### **CITY OF MERCER ISLAND**

#### Pre-Application Meeting (PRE20-038)

Site Location:	9820 SE 35 <sup>th</sup> PL							
Lot Size:	21,700s	f	Zoning:	R-9.6 (Single Family)				
Brief Project Description:	:		Documents Provided:	Easement info, fire gross sf, Geotech report, GIS map, hazard report, narrative & questions, plan set, plat map, and pre-app form.				
Applicant Infor	mation:							
Name:			Email:		Phone:			
Priscilla Wenzel			priscilla@mediciarchitects.com		602-568-5689			
Second Pre-application Meeting Required: Not Applicable			Click for explanation if necessary

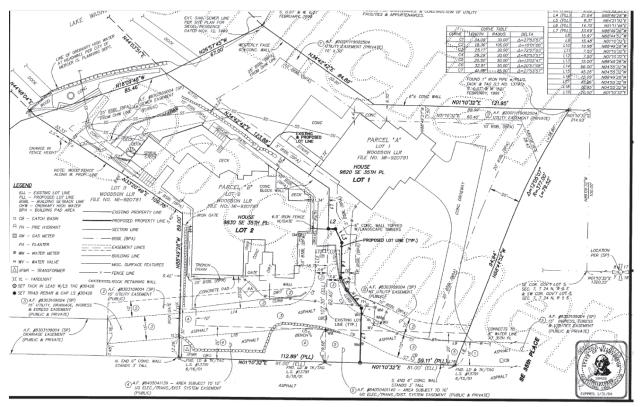
- a. Lauren Anderson (Planning) response: this Affidavit should be submitted with the building permit.
- 2. Less than 40% of the exterior will be structurally altered. The existing house is placed with the Northern side yard measuring 5 ½ feet while the Southern side yard measures 9 ½ feet and an aggregate total of 15 feet. Since the site has not been altered, it is our understanding that the existing side yards are vested. At the basement level, the existing basement will be extended 12 feet for a new Sitting and Exercise Room. This extension aligns with the current existing structure and sits on the existing exterior stair footing. The stair will be removed, and the existing footing reused for the Sitting Room foundation upon approval from structural. This existing footing is 7'-5 ½" to 8'-2" from the Northern property line. Does the location of the proposed extended basement comply with the required set back? Does the 5 ½ foot vested setback apply for the new addition?

- a. Lauren Anderson (Planning) response: the recorded setbacks on the plat do vest. There was a lot line revision in 1993 under SUB9206-014 please refer to Attachment 1. In 2001 there was the Baker lot line revision under SUB01-009, Recording #20021125900027 refer to Attachment 2.

b. The setbacks that were recorded on the latest subdivision is what the project vests to – thus the side yard setbacks are 10 feet to the south and 5 feet to the north that then becomes 10 feet for the northwest portion – refer to Attachment 2. Please refer to the snippet below:

#### c. Figure C: Vegetation Plan

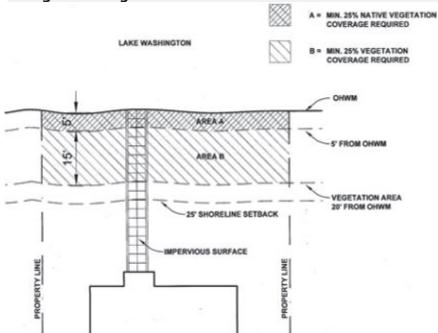
- b. <u>https://mercerisland.municipal.codes/MICC/19.13.050(K)(4)</u> shoreline planting required:
    - i. New development totaling 500 square feet or more of any combination of additional gross floor area, lot coverage or hardscape, including the primary structures and appurtenances, shall be required to provide native vegetation coverage over 50 percent of the 20-foot vegetation area shown on Figure C. This total shall include all gross floor area, lot coverage, and hardscape added in the five years immediately prior to the development proposal.

i. New development totaling 1,000 square feet or more of any combination of additional gross floor area, lot coverage or hardscape, including the primary structures and appurtenances, shall be required to provide native vegetation coverage over 75 percent of the 20-foot vegetation area shown in Figure C.

- ii. A shoreline vegetation plan shall be submitted to the city for approval.
- iii. The vegetation coverage shall consist of a variety of ground cover shrubs and trees indigenous to the central Puget Sound lowland ecoregion and suitable to the specific site conditions. Existing mature trees and shrubs, but excluding noxious weeds, may be included in the coverage requirement if located in the 20-foot vegetation area shown in Figure C.
- iv. No plants on the current King County noxious weed lists shall be planted within the shorelands.
